Return Loss Specifications for C2C Tx and Rx

Mike Dudek Cavium
Nikhil Patel Cavium

802.3 Plenary July 2017 Berlin

Return Loss at TP0a (Test trace = 90ohms)

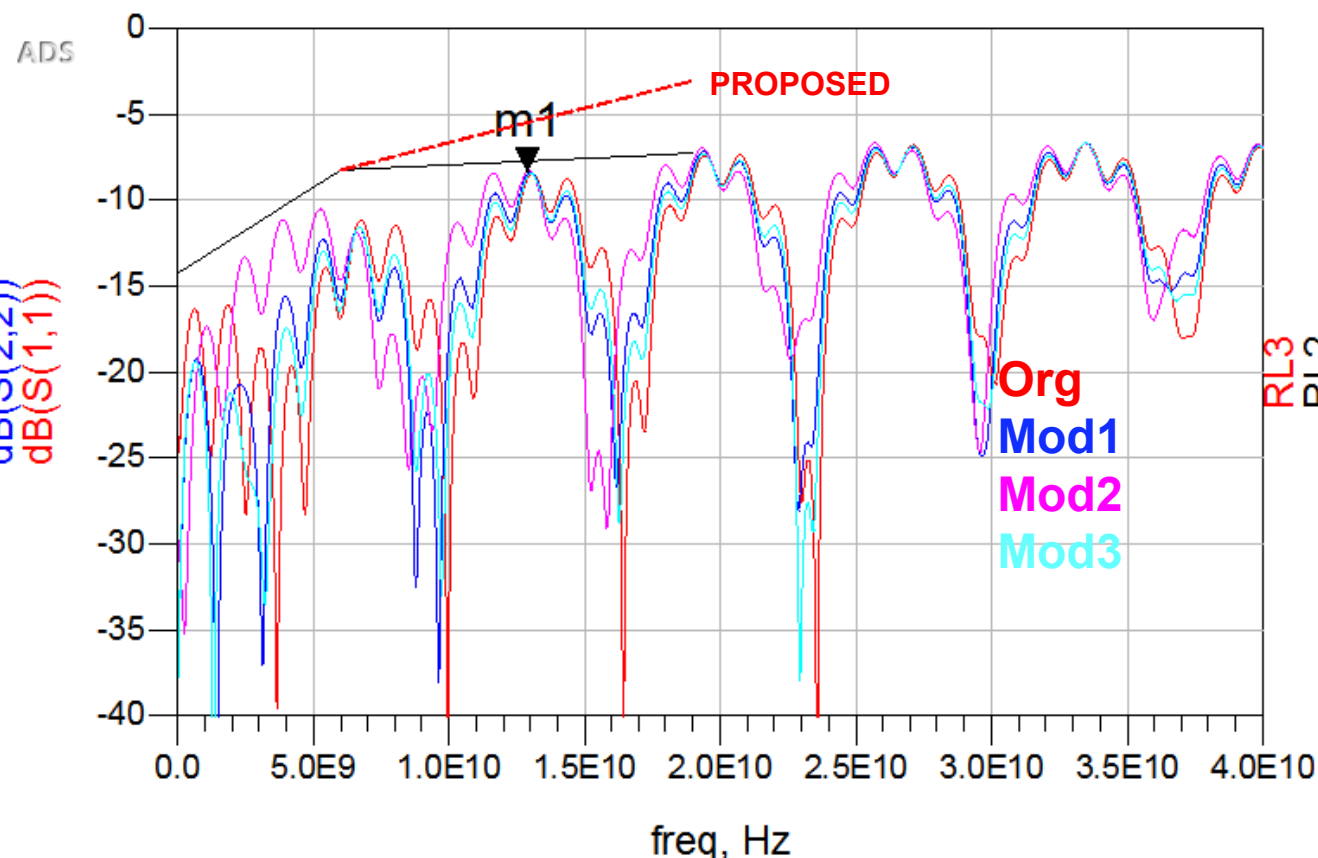
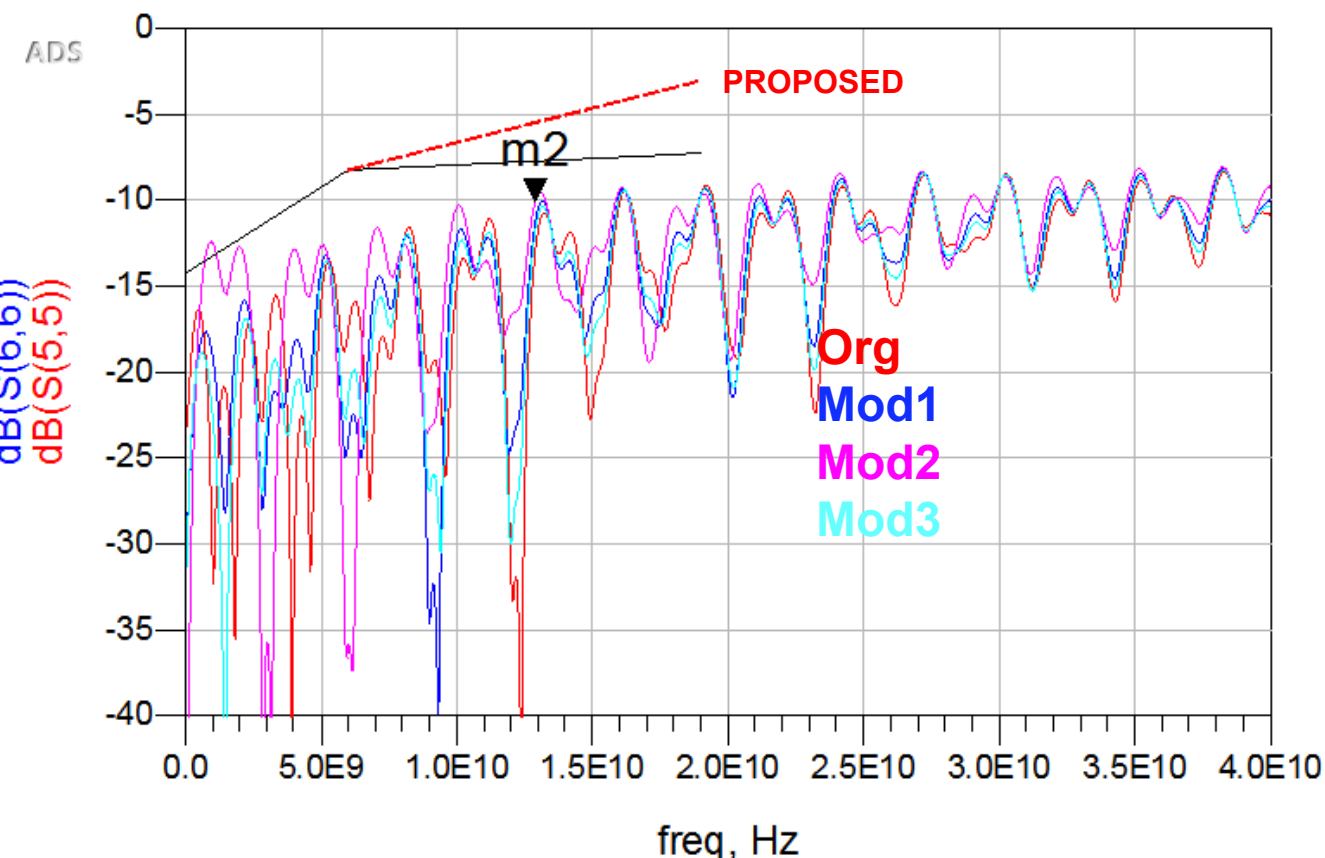
- **The effect of changing R_d and Z_c on the return loss measured at TP0a is not great. It is therefore not possible to control the R_d and Z_c impedances using the return loss at TP0a.**
- **At higher frequencies the D3.2 return loss specification is too tight particularly for the short package. Note that these simulations do not include the additional degradations due to a non-ideal connector (or vias) at TP0a.**

- Change the second half of the Tx and Rx return loss specifications as highlighted below

$$RL_d(f) \geq \left\{ \begin{array}{ll} 14.25 - f & 0.05 \leq f \leq 6 \\ \text{10.65} - 0.4f & 6 < f \leq 19 \end{array} \right\} \text{ dB} \quad (120D-2)$$
